REMARKS

Serial No. 09/777,504

Amendment in Reply to Office Action of September 13, 2004

FIG. 2

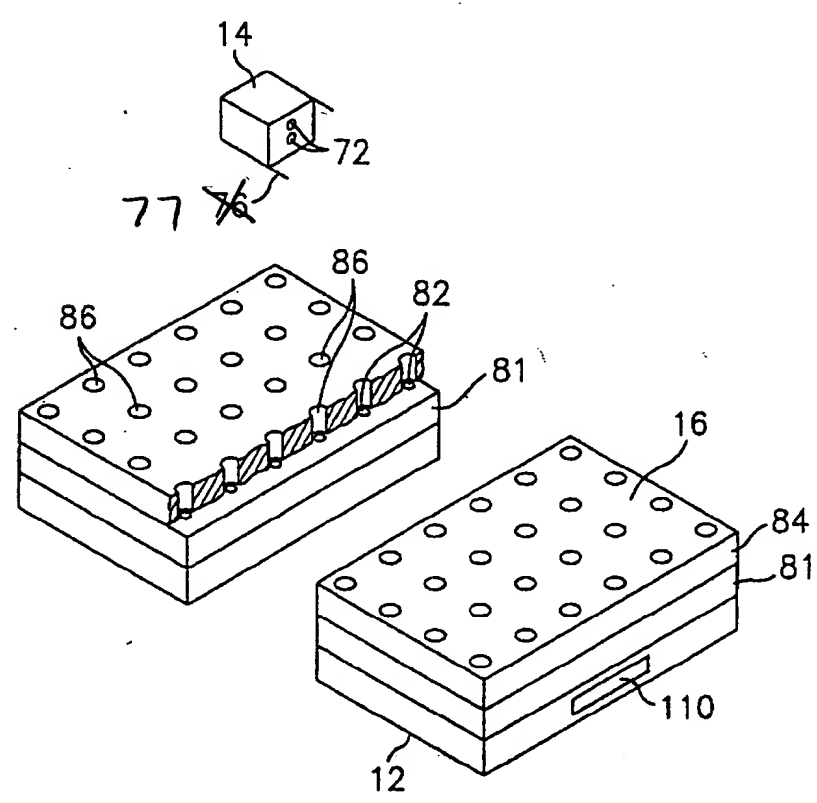
By means of the present amendment, the drawings have been amended to change reference numeral 76 in FIG 2 to 77, for conformance with description thereof on page 8, line 11 of the specification. A replacement sheet including FIGs 1-2 is enclosed. Further, an annotated drawing sheet with marked-ups in red of the sheet showing changes to FIG 2 is enclosed for convenience. Applicant respectfully requests approval of the enclosed proposed drawing changes.

Please replace FIG 2 with the enclosed substitute FIG 2.
